# REPLACE THE WATER PUMP 65906 WITHOUT CASING IN THE 66601 WITH AN ALUMINIUM CASING

TECHNICAL INFO NO. 1121

Picture 1: Water pump 65906 without casing (old)

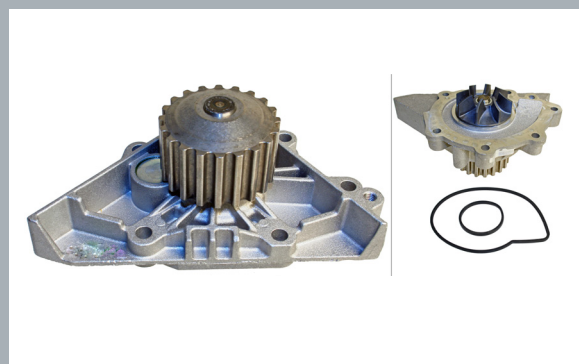
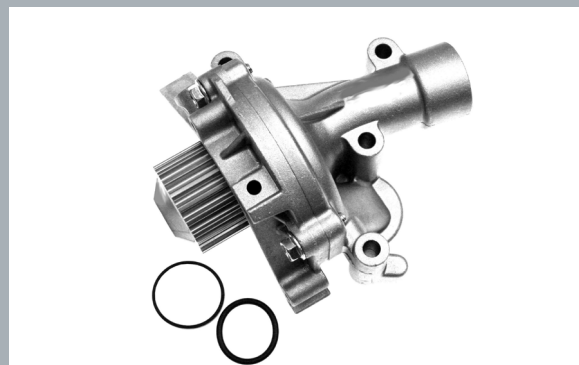
The OE has changed the casing of the water pump from a plastic casing to one made of aluminium.

As a result of this change, RUVILLE now only supplies the water pump with a casing. This prevents the pump insert 65906, which is made of aluminium, being fitted with the plastic casing that may be in the vehicle. This also avoids any sealing problems arising from the different materials.

For this reason, RUVILLE will replace the pump insert 65906 in the water pump with the casing 66601.
